**Notice of Meeting for the
Historic and Architectural Review Commission
of the City of Georgetown
April 9, 2020 at 6:00 PM
at**

- D **Public Hearing** and **possible action** on a request for a **Certificate of Appropriateness** for an addition that creates a new, or adds to an existing street facing façade at the property located at 701 University Avenue, bearing the legal description of 0.31 acres out of the southwest portion of Block 2, Snyder Addition. – Britin Bostick, Downtown & Historic Planner

- E **Public Hearing** and **Possible Action** on a request for a **Certificate of Appropriateness** for a 19.3’ setback encroachment into the 25’ required garage (west) setback, a 6’ setback encroachment into the required 6’ side (north) setback, and a 3’ building height increase from the required 15’ maximum building height at the side (north) setback line allowing for a building height of 18’ at the side setback at the property located at 403 E. 4th Street, bearing the legal description of 0.472 acres out of Block 24, OUTLOT DIVISION C. – Britin Bostick, Downtown & Historic Planner

- F **Public Hearing** and **Possible Action** on a request for a **Certificate of Appropriatenes

403 E. 4th Street – new design (Elm St. Elevation)

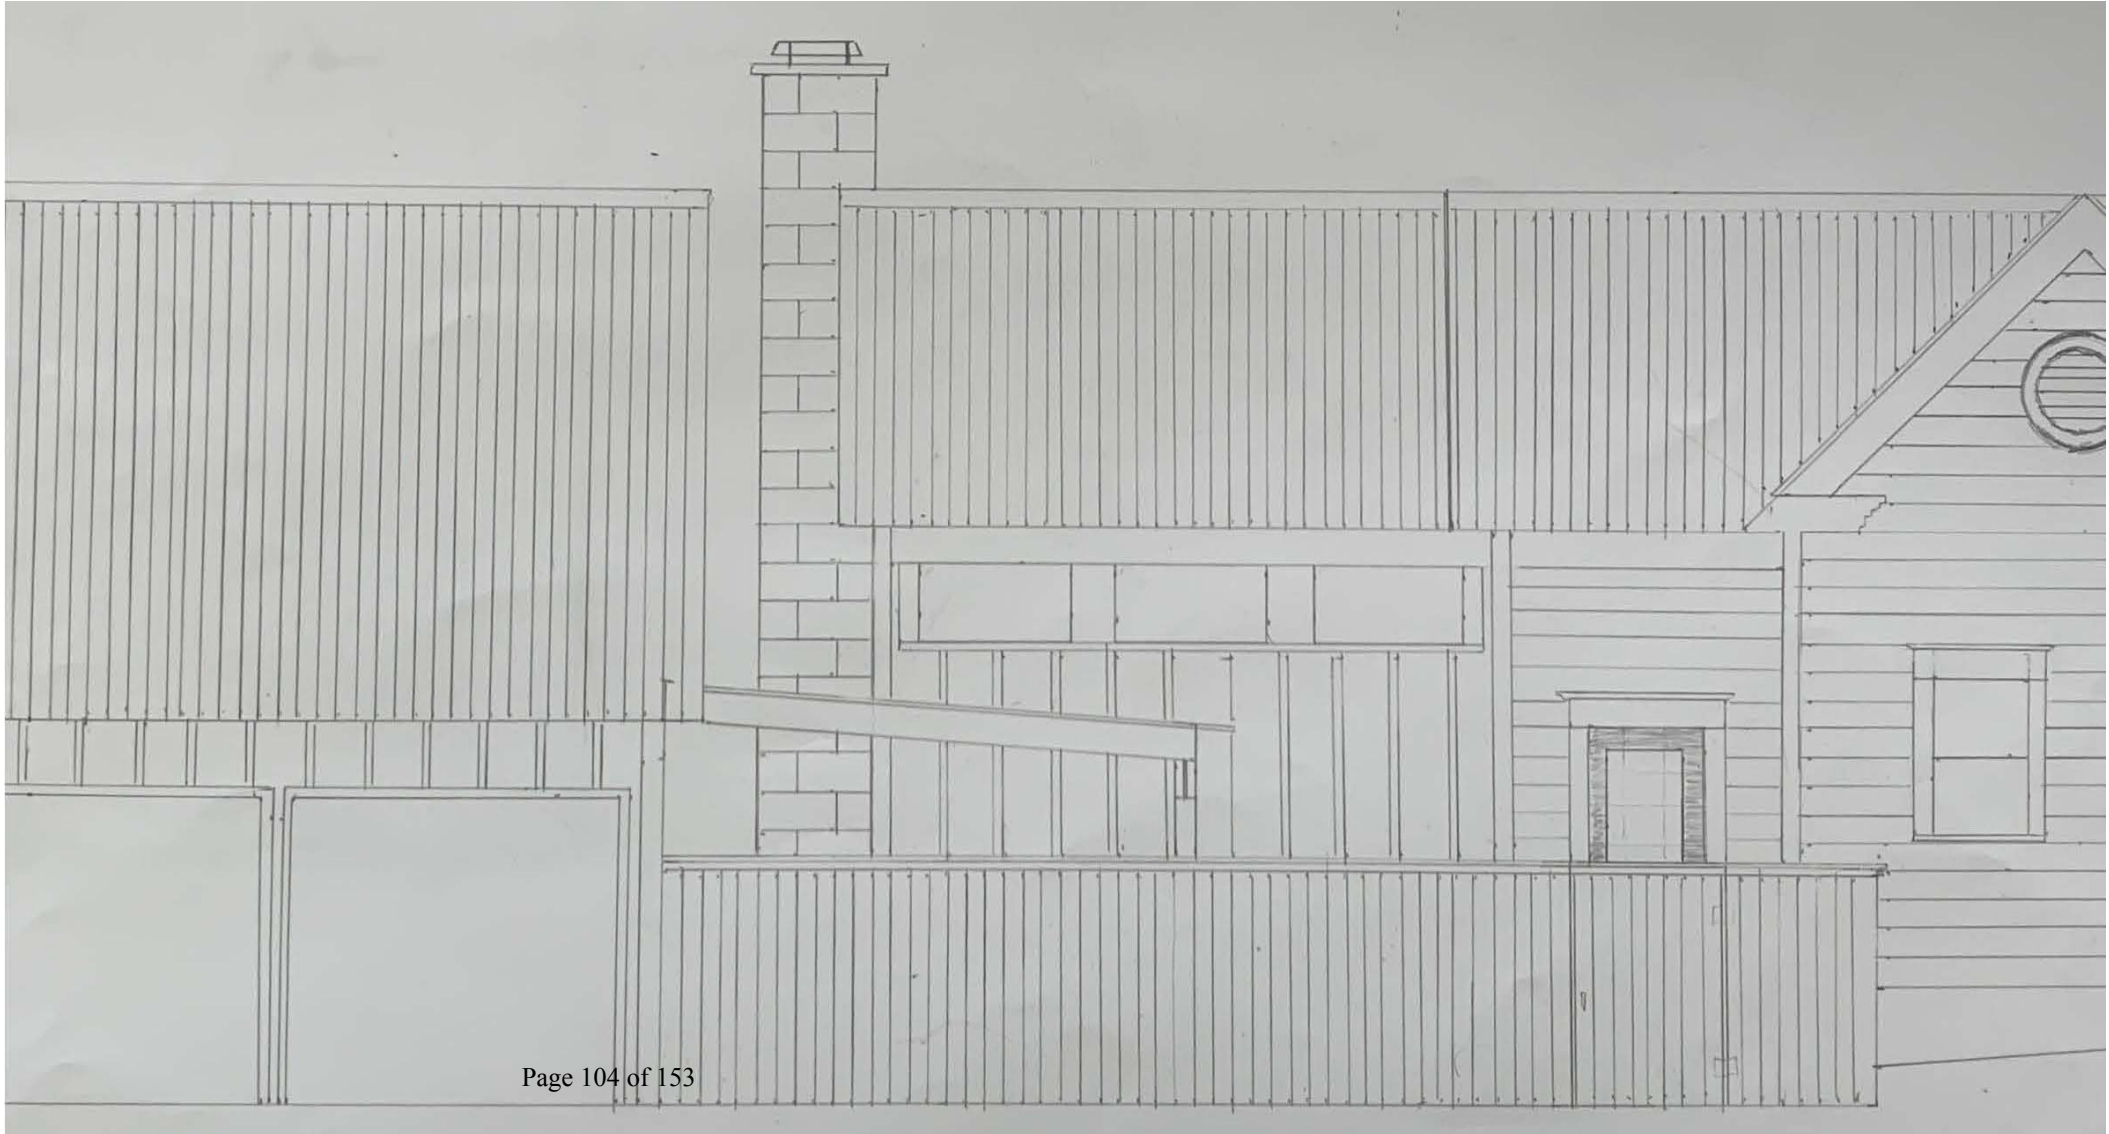
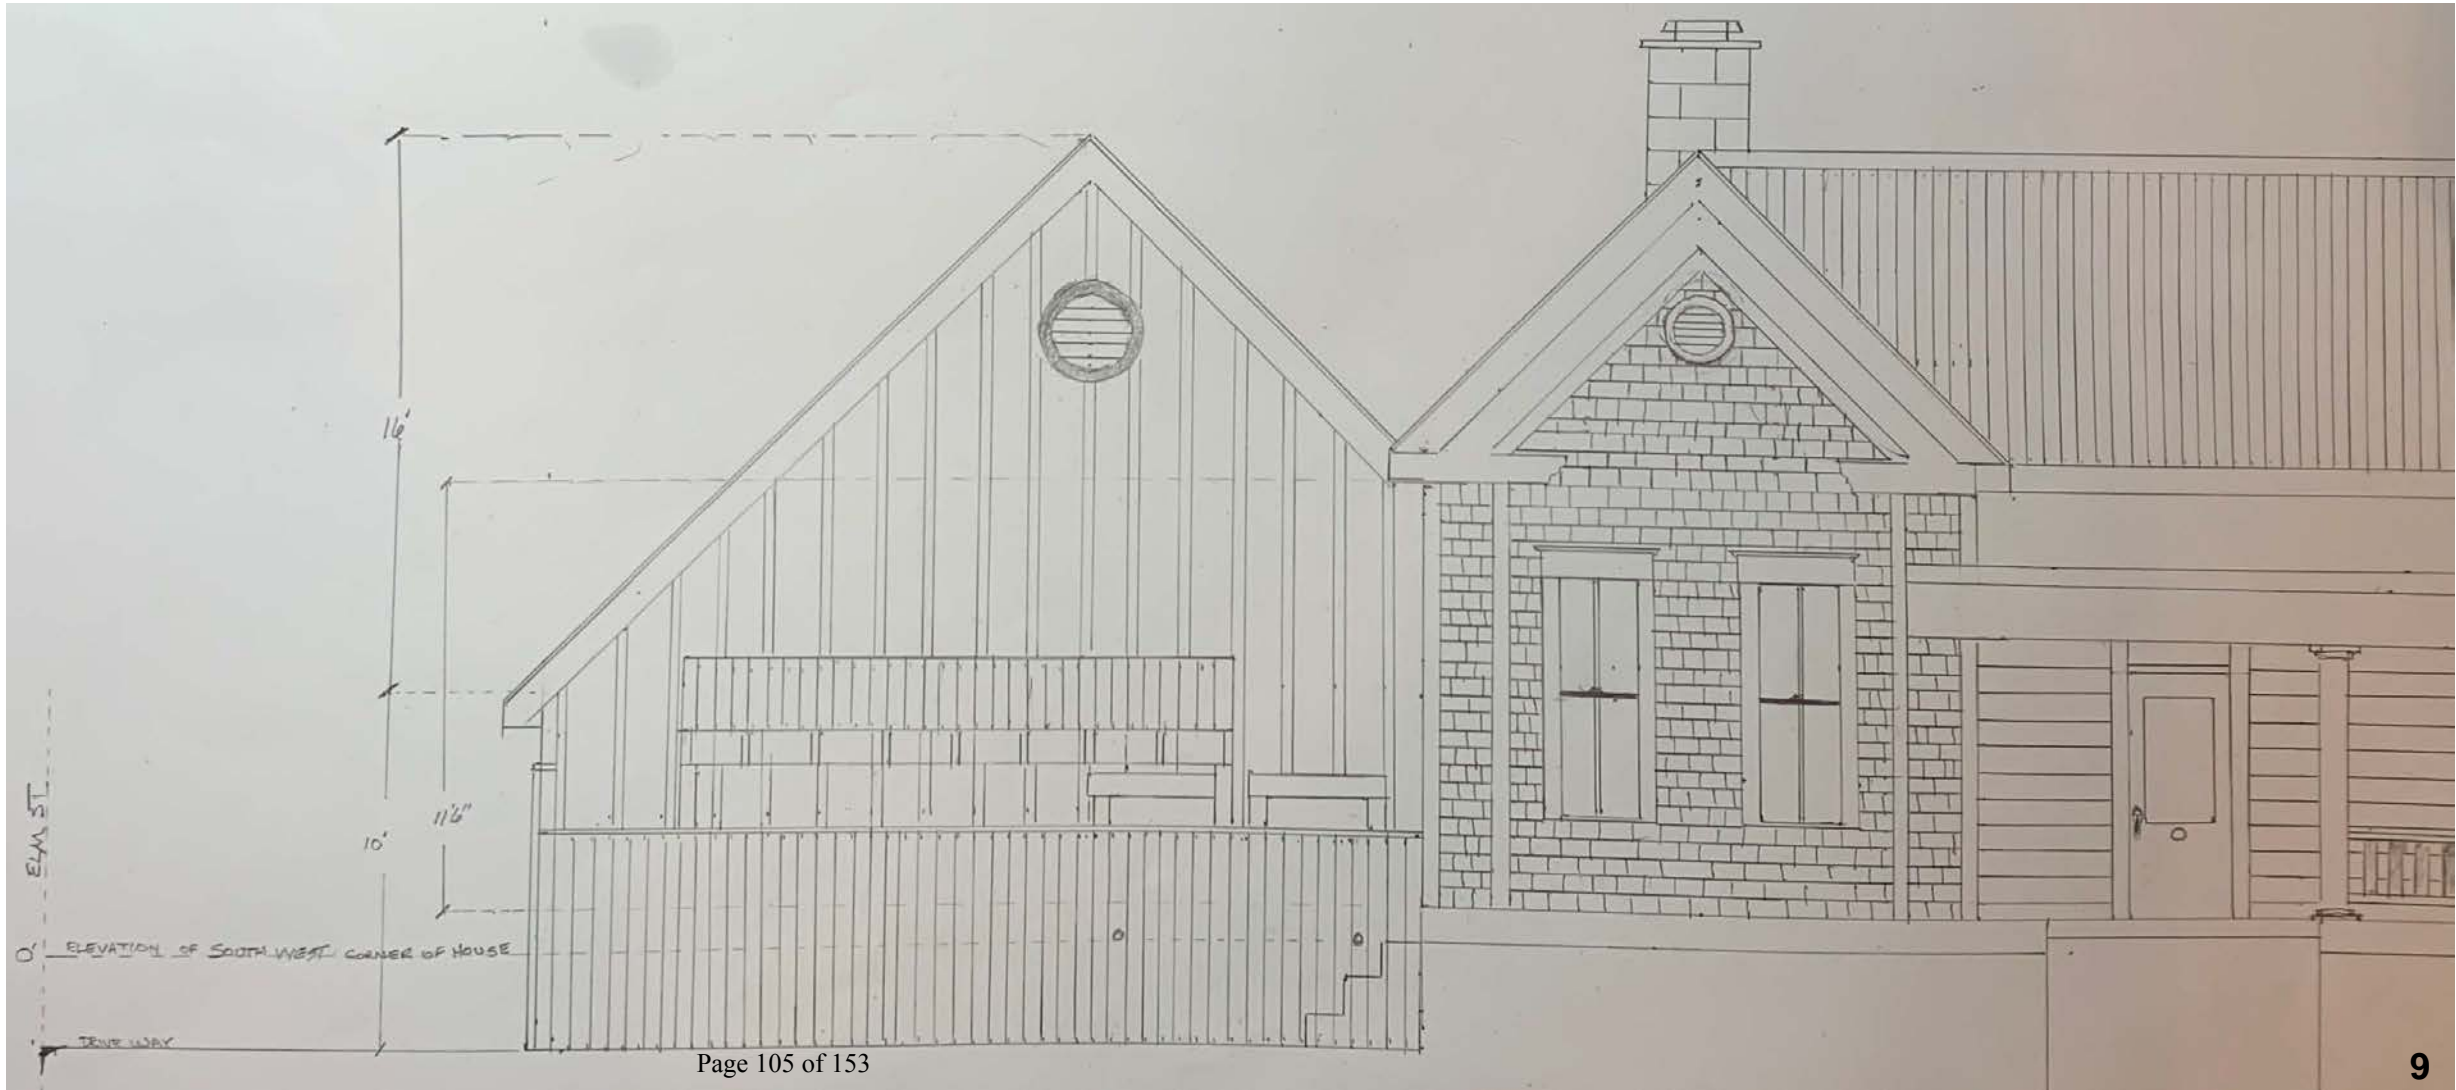
- Change the roof from a flat roof to a 12/12 pitched gable roof, with the gable ends facing north and south (orientation to address concerns about rainwater runoff), with a height to accommodate attic storage over the garage space. The attic will be accessed via interior stairs, and there is storage space at the rear of the garage.
- Add two overhead garage doors to the street-facing façade (Elm Street), two doors on the south side of the garage for access to the garage and storage room from the yard and a pass-thru window with shutters in the south façade.
- Use board and batten siding and metal roof to match the main structure.
- Add a 224 sq. ft. covered patio or roofed pergola structure to the south façade of the garage with a slightly sloped roof of the same metal as the garage roof.

Because the existing accessory structure is situated within the side street and side setbacks, and is proposed to be expanded within those setbacks, the request to HARC is for approval of setback modifications to allow the existing structure to be enlarged as a detached garage, and encroach 19.3' into the 25' required garage setback that applies, and to encroach 6' into the required 6' side (north) setback,

Height modification to allow 19'6 at side (south) setback

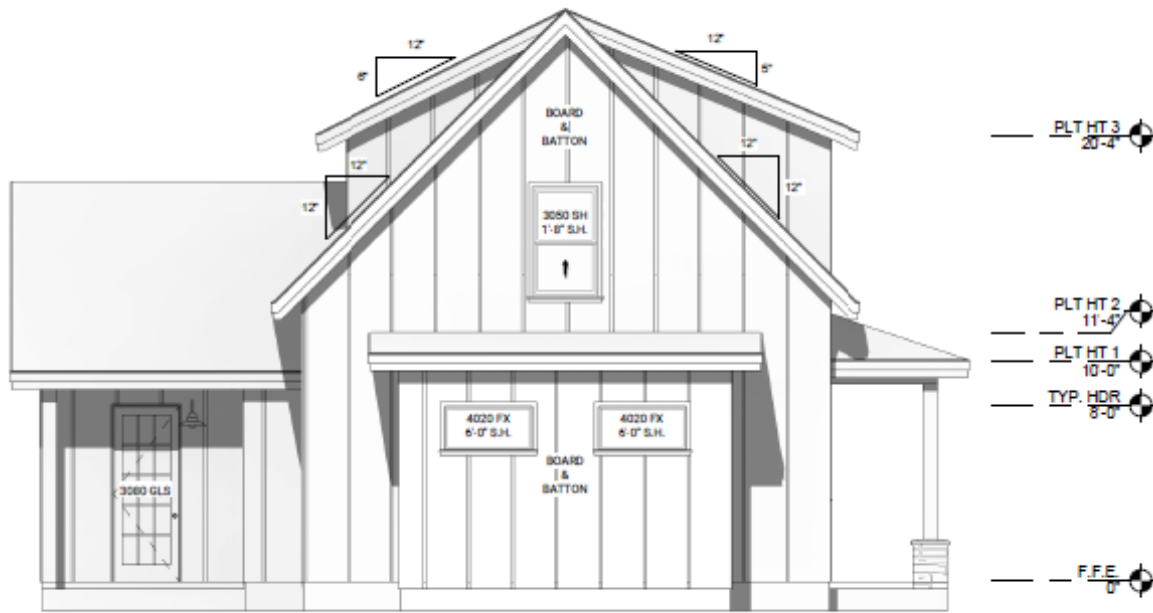
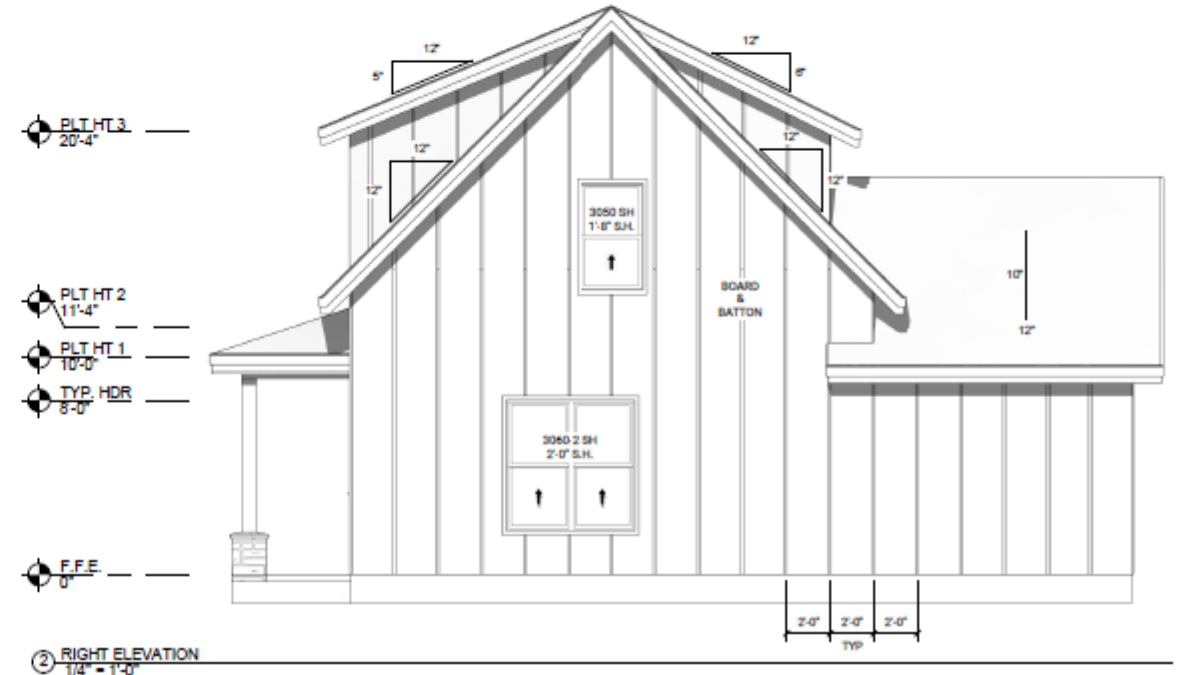
Height modification to allow 19'6" at side (south) setback
